**PCN# 20150506001**

**Qualification of RFAB and Vanguard as an additional wafer fab site options for select devices**

**Change Notification / Sample Request**

Sample product shipping label (not actual product label)

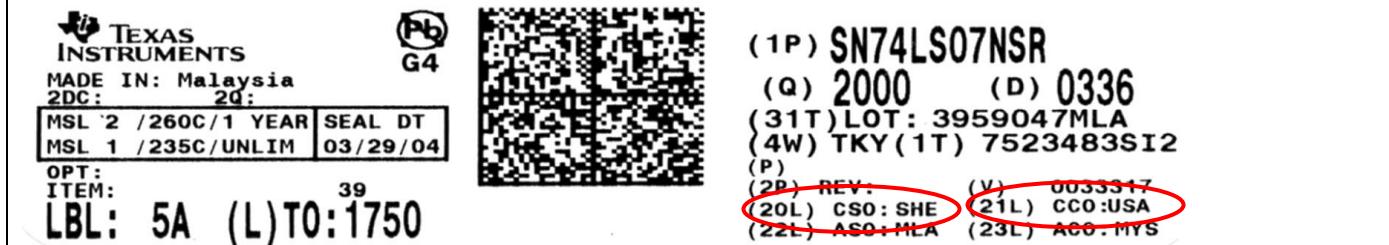
#### Changes to product identification resulting from this PCN:

Chip Sites	Chip site code (20L)	Chip country code (21L)
ANAM-1	ANM	KOR
TSMC-WF2	TS2	TWN

Chip Site	Chip site code (20L)	Chip country code (21L)
RFAB	RFB	USA
Vanguard (VIS)	VAN	TWN
